NOTICE OF DECISION

CLASS 2 SITE PLAN REVIEW

APPLICATION NO.: 24-117455-PLN

REQUEST: A Class 2 Site Plan Review for the removal and replacement of pavement for an existing warehousing and distribution use for a property 1.81 acres in size and zoned IG (General Industrial), located at 2711 19th Street SE (Marion County Assessor's Map and Tax Lot 073W35CD0 / 400).

SHEET NO.:	DESCRIPTION:
C0-00	COVER SHEET
C0-01	EXISTING CONDITIONS
C1-00	SITE PLAN
C2-00	CONSTRUCTION DETAILS
C2-01	PAVEMENT CORING INFORMATION
C3-00	GENERAL NOTES

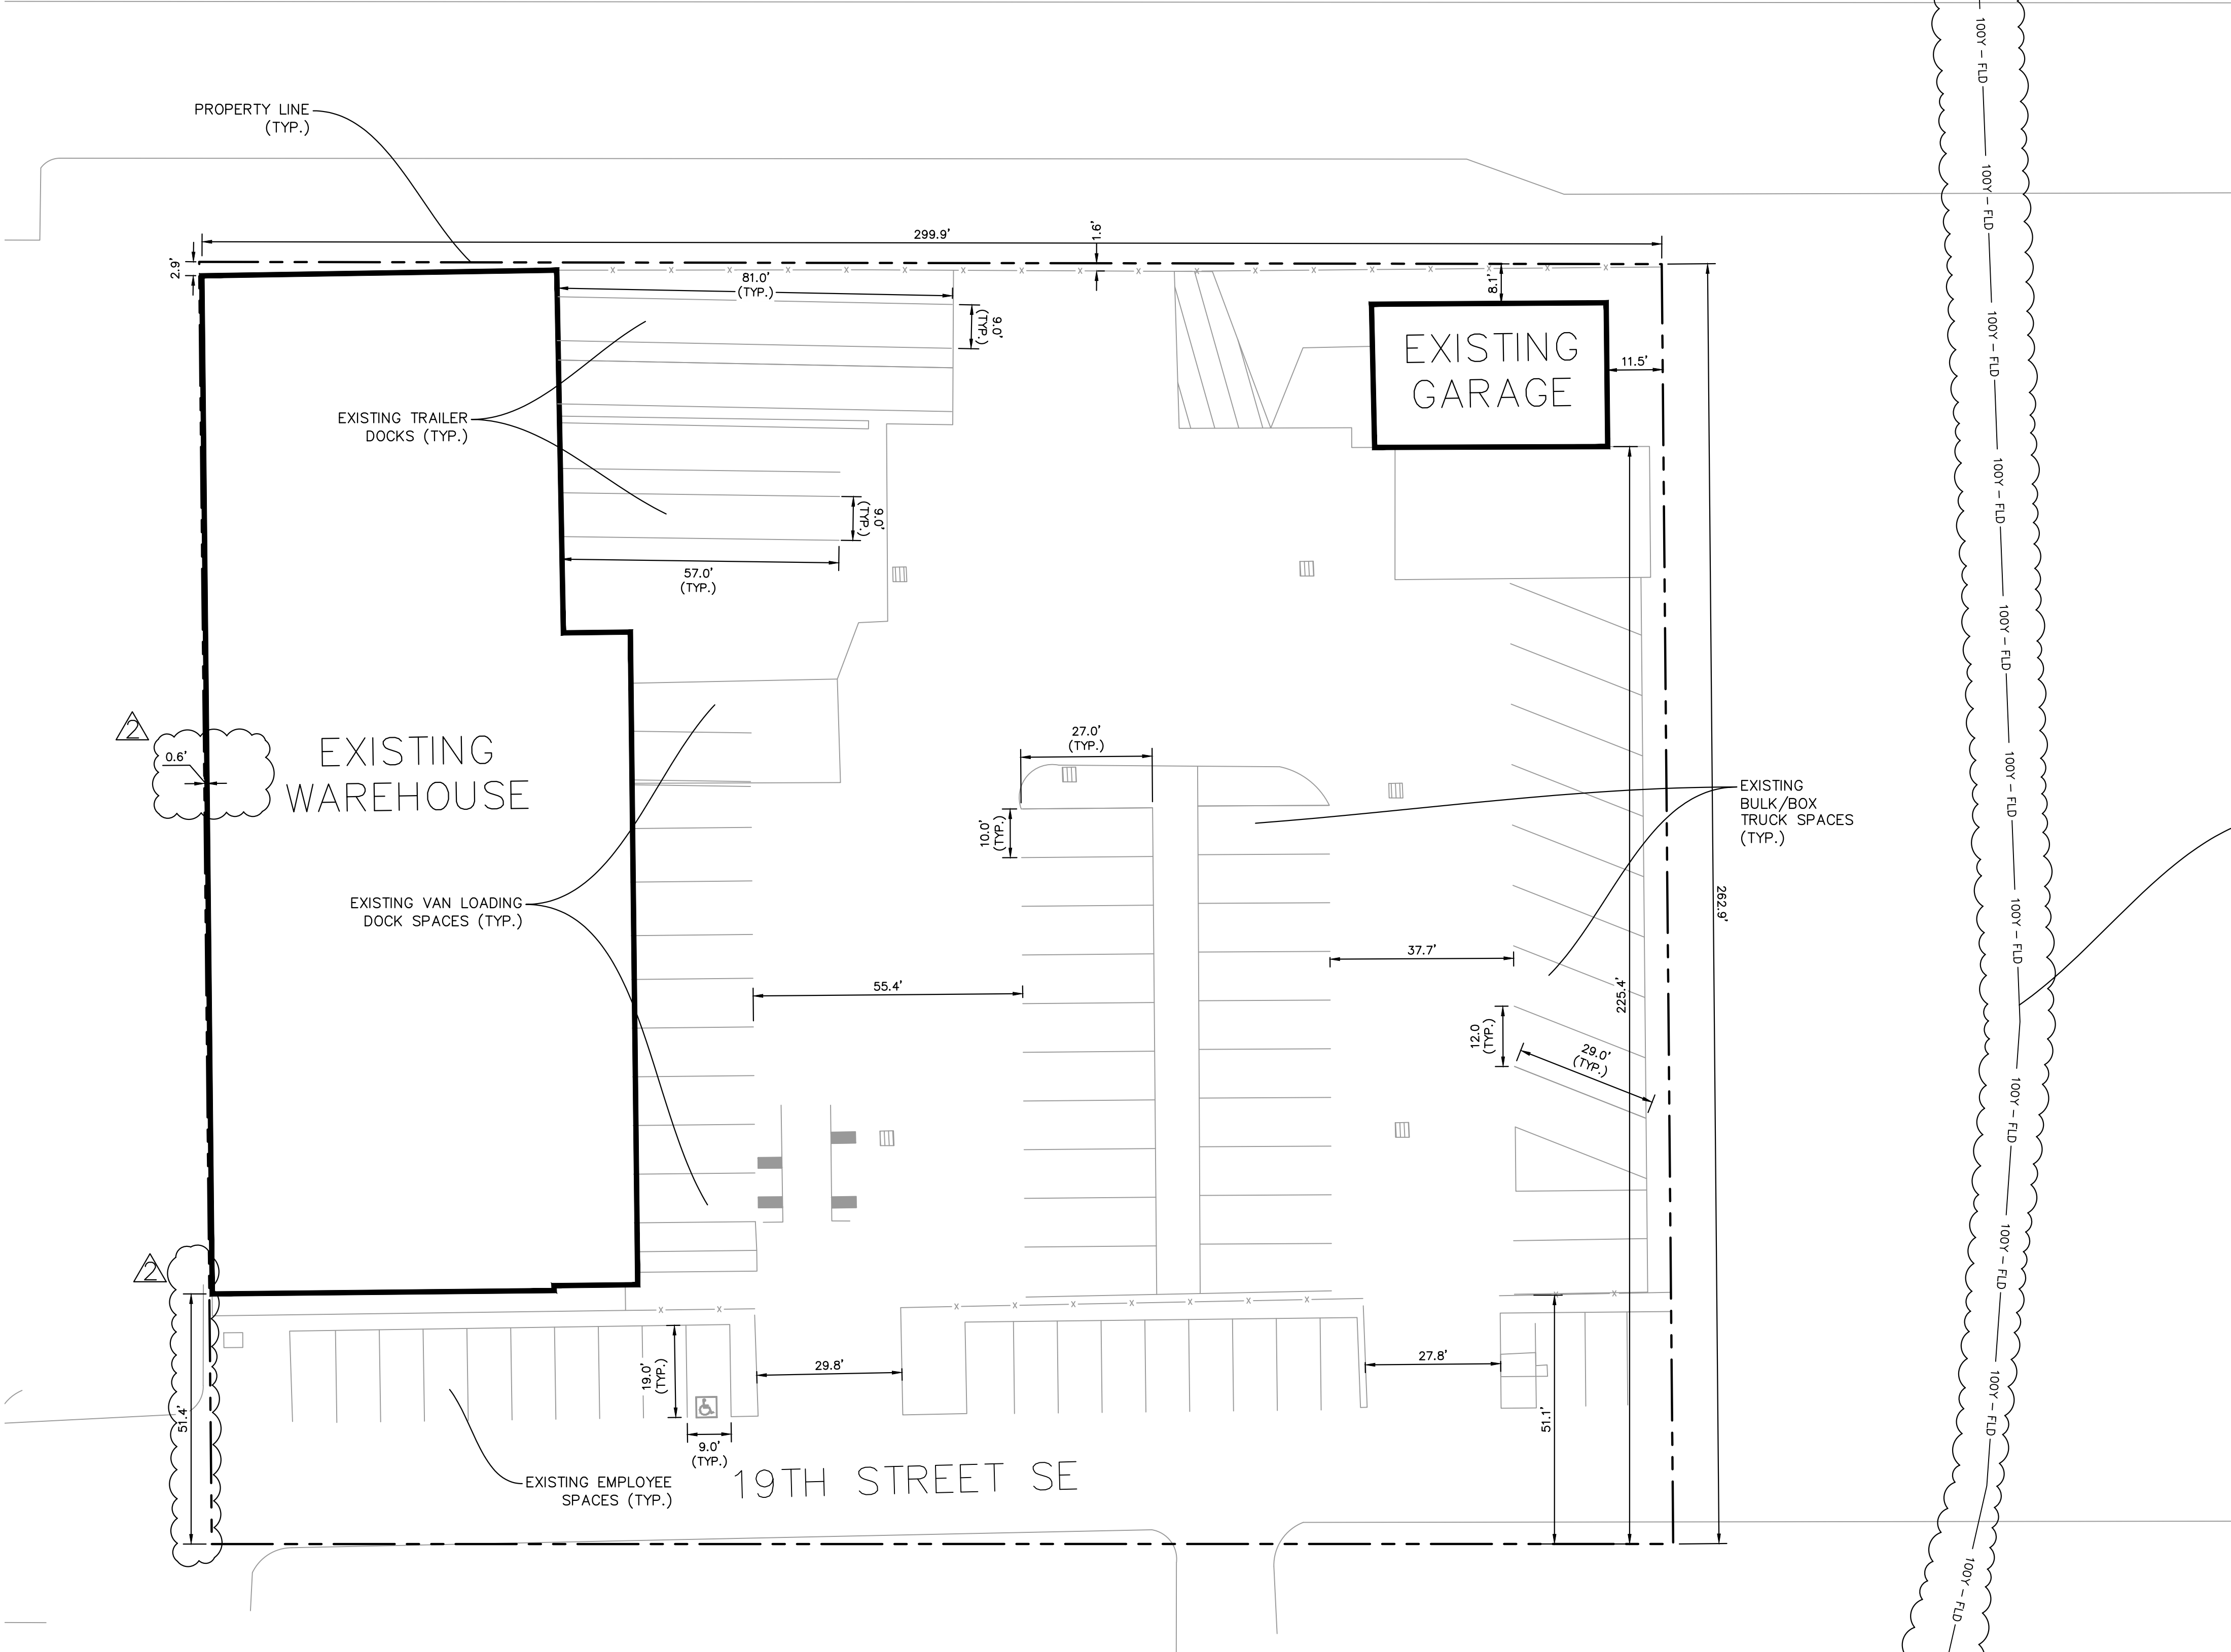
Finding: The site plan indicates the proposed bicycle parking is within 50 feet of a primary entrance; therefore, this standard is met.

Finding: As shown on the site plan, the bicycle parking area has direct access to the primary building entrance free of obstruction or barrier. There are also no obstructions between the proposed bicycle parking area and the shared-access easement, meeting the standard.

Finding: The applicant's site plan indicates the addition of four new bicycle parking spaces located near the proposed building, meeting the development standards of SRC 806.060. This standard has been met.

Finding: The proposed bicycle parking spaces are proposed to be located on a hard surface material; therefore, the standard is met.
